S.I.L. NO. 01-560-04

SERVICE INFORMATION LETTER

FROM: JetProp LLC

SUBJECT: Larger Air Conditioner Drive Pulley

Figure 1. Engine as Viewed Through the Generator Access Panel

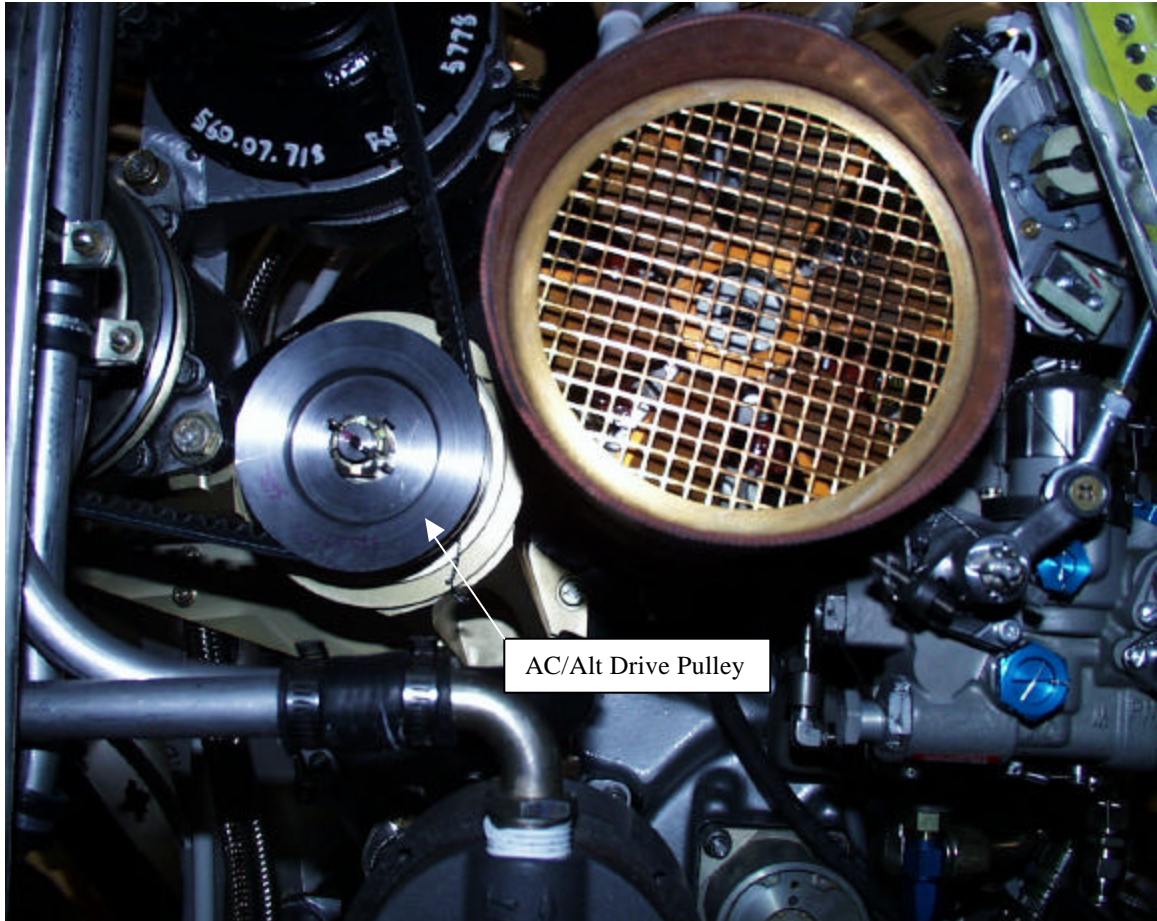
3. Remove the generator access panel to gain easy access to the AC/Alt Drive Assembly. See Figure 1.
4. Remove the cotter pin and the nut holding the dual drive pulley on the AC/Alt Drive Assembly shown in Drawing 560.07.710.

5. Remove the pulley from the shaft.
6. Ensure the woodruff key is in place and install the new larger pulley. Some pulleys have more than one key way so be sure to use the small key way that matches the size of the woodruff key in the shaft. Also, the pulley fits snug on the shaft. It may be necessary to use some emery cloth on the pulley to get the proper fit on the shaft.

7. Replace the retaining nut and washer. Torque the nut to 40 – 58 Ft-Lb and install the cotter pin.
8. Loosen the alternator retaining bolts to allow the alternator to move in the belt tension arm to the loose position. Install the new belts. Adjust the belt tension to obtain a tension of 45 pounds for new belts or 23 to 34 pounds for old belts. With the belts tight, tighten the alternator retaining bolts and safety wire (.032 wire) the alternator tension arm bolt.
